APPLICATION NO.	FILING DATE	FIRST NAMED INVENTOR	ATTORNEY DOCKET NO.	CONFIRMATION NO.
10/553,392	07/27/2006	Mariano Pecorari	SAH001WUS/AG/bp	9044
21254	7590	12/22/2008	EXAMINER	
MCGINN INTELLECTUAL PROPERTY LAW GROUP, PLLC			HUTCHINS, CATHLEEN R	
8321 OLD COURTHOUSE ROAD			ART UNIT	PAPER NUMBER
SUITE 200				3672
VIENNA, VA 22182-3817			MAIL DATE	DELIVERY MODE
			12/22/2008	PAPER

<b>Office Action Summary</b>	<b>Application No.</b> 10/553,392	<b>Applicant(s)</b> PECORARI ET AL.
	<b>Examiner</b> CATHLEEN R. HUTCHINS	<b>Art Unit</b> 3672

## DETAILED ACTION

Fig A: taken from Ricalton, et al. Fig 1.

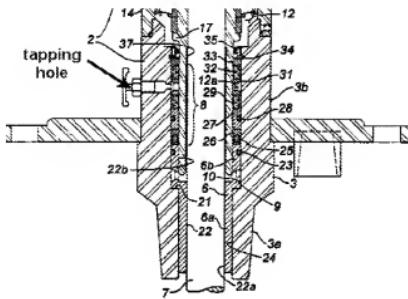
Claims 1, 2, 4-6, and 10-13 are rejected under 35 U.S.C. 102(b) as being anticipated by Ricalton, et al. US5791411.

Ricalton, et al. teaches a pump drive head with an integrated stuffing box 1 comprising: a power transmission that rotates the rod 39, as described in the Abstract, coupled to a rotating pump drive shaft 39; a stuffing box 1; a thrust assembly 13 to take tensile force; wherein power transmission comprises a tube 11 to be rotated coaxially with the shaft having two different diameters with the larger diameter at top at 11b and the smaller diameter below along reference number 8, which is connected at its bottom end to a sleeve 6 for rotation, wherein rotary seals 42 fit over the smaller diameter of the tube to establish fluid seals between the tube and stuffing box, the outside diameter of the seals smaller than the larger outside diameter of the tube, and wherein the tube-to shaft fit has static seals 8, in which the seals are adapted, by virtue of a retainer ring 27, to come away with the tube; a gasket 26 connected to the retainer ring of the seals on the sleeve; an outside-communicated tapping hole see Fig A below downstream of the gasket and the seals; rotary seals include packing seals 32, oil seals 29 downstream of the rotary seals and inlet hole, with packing mounted between the tube and inner seat of the stuffing box; static seals are in the joint region between tube 11 and sleeve 6 and compressed to make a seal in the skirt of the top cover that is along 2; the tube is connected to the thrust assembly for rotation by rotating hub 20 held in place by tighten-down means 11a in the upper portion of the drive housing with a roller thrust bearing and bell 5 to enclose the hub and bearings.
